SERVICE/PARTS BULLETIN

Subject: Covers Over the Main Drive Shaft Clutches
Models: 3000 through 4100

SECTION "B-B"

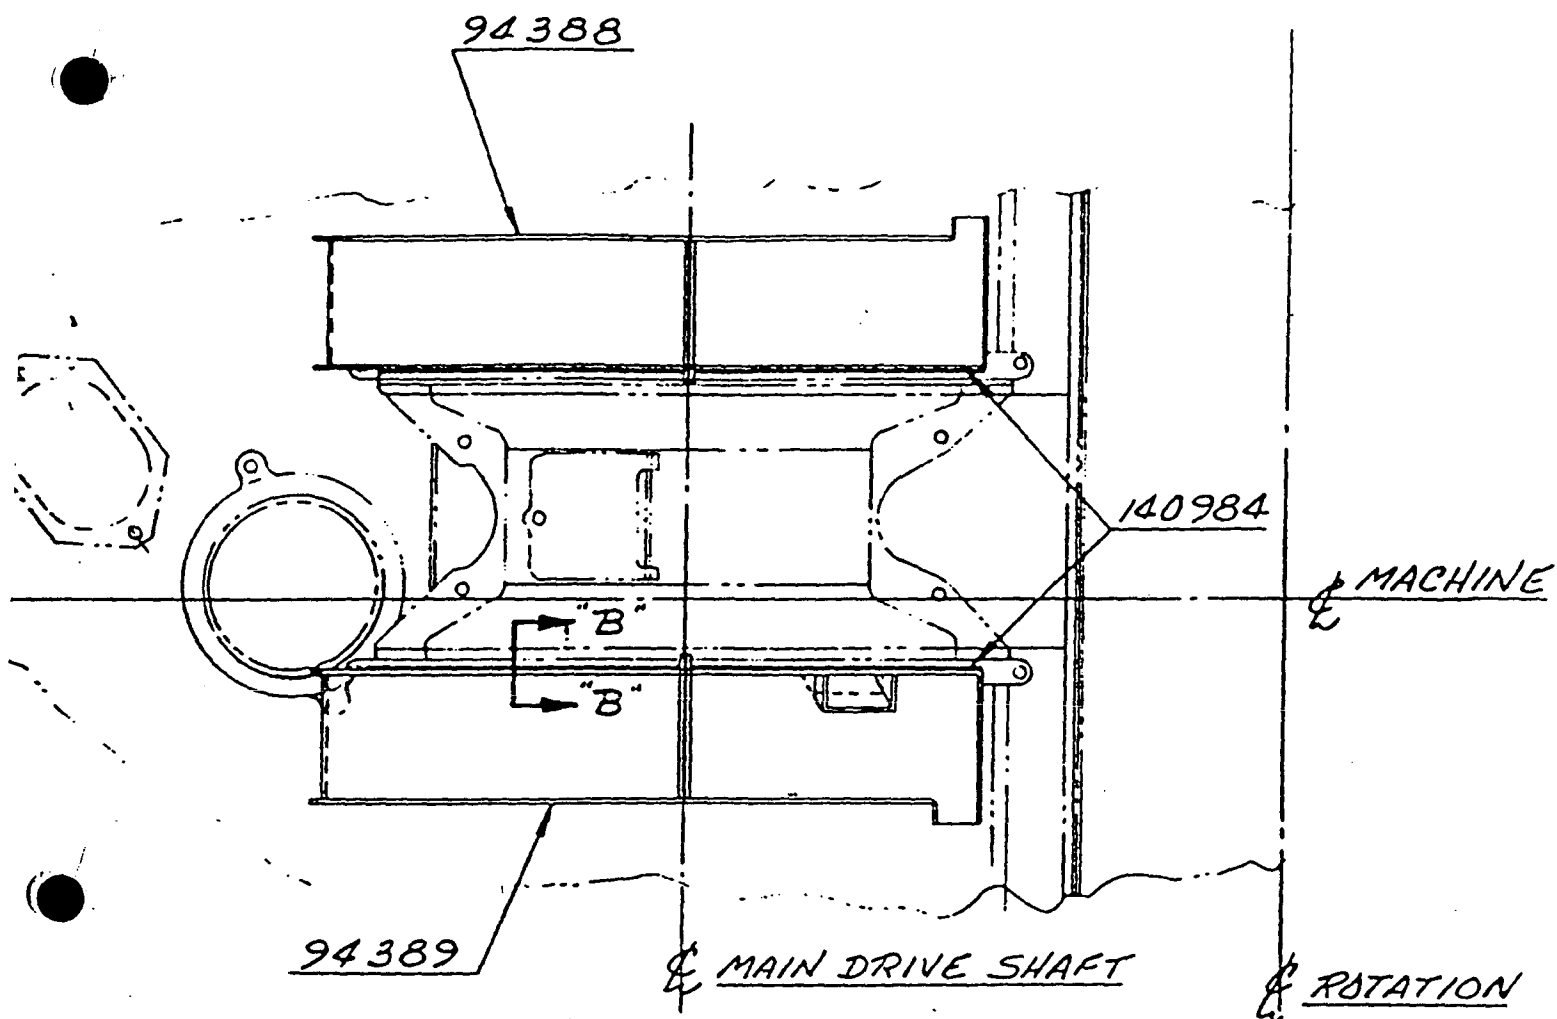
Covers can be installed over the main drive shaft clutches to improve water tightness.

Covers will not fit on machines equipped with a clutch cooling system (blower).

Parts needed:

- 1 - 94388-2 Guard
- 1 - 94389-2 Guard
- 2 - 140984-2 Gasket
